eceived by UCD: 2/11/2025 4:57:18 PM U.S. Department of the Interior BUREAU OF LAND MANAGEMENT		Sundry Print Report 04/11/2025
Well Name: JRU APACHE FEDERAL COM	Well Location: T22S / R30E / SEC 13 / NESE / 32.391762 / -103.828231	County or Parish/State: EDDY / NM
Well Number: 112H	<b>Type of Well:</b> CONVENTIONAL GAS WELL	Allottee or Tribe Name:
Lease Number: NMNM89051	Unit or CA Name: JAMES RANCH UNIT	Unit or CA Number: NMNM70965X
US Well Number: 3001555529	<b>Operator:</b> XTO ENERGY INCORPORATED

### **Notice of Intent**

**Procedure Description:** XTO Energy Incorporated, respectfully requests approval to make the below listed changes to the approved APD: 1. Casing design to be changed from the "4-String Design – Engineered Weak Point" (FIGURE F) to the "4- String Design – Open 1st INT x 2nd INT Annulus" (FIGURE D). An open annulus will be utilized and monitored during completions operations. Post completion, bradenhead squeeze will be performed to tie back the 1st intermediate x 2nd intermediate annulus. TOC will be placed into the 1st intermediate shoe but still below the base of Potash interval. 2. No changes to the cementing, casing or mud circulating system designs will b

[Figure F] 4 String - 2<sup>nd</sup> Intermediate casing engineered weak point

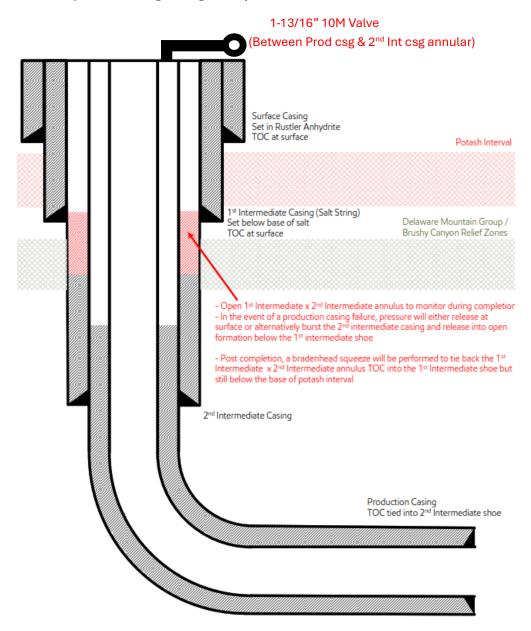
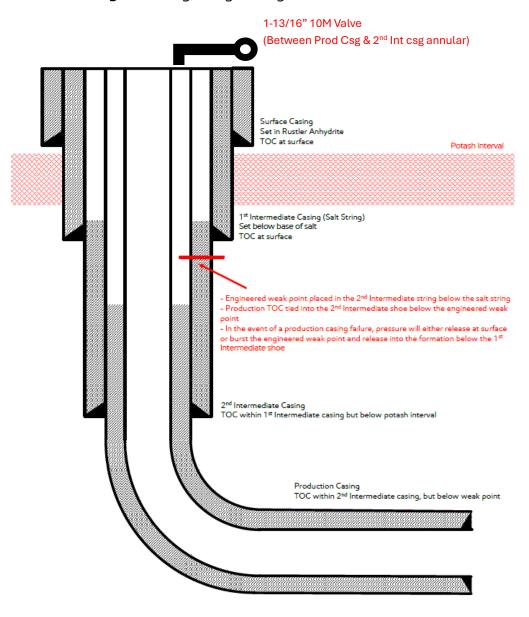
1. Casing design to be changed from the "4-String Design – Engineered Weak Point" (FIGURE F) to the "4-String Design – Open 1<sup>st</sup> INT x 2<sup>nd</sup> INT Annulus" (FIGURE D). An open annulus will be utilized and monitored during completions operations.

Post completion, bradenhead squeeze will be performed to tie back the 1<sup>st</sup> intermediate x 2<sup>nd</sup> intermediate annulus. TOC will be placed into the 1<sup>st</sup> intermediate shoe but still below the base of Potash interval.

2. No changes to the cementing, casing or mud circulating system designs will be required for the requested change.
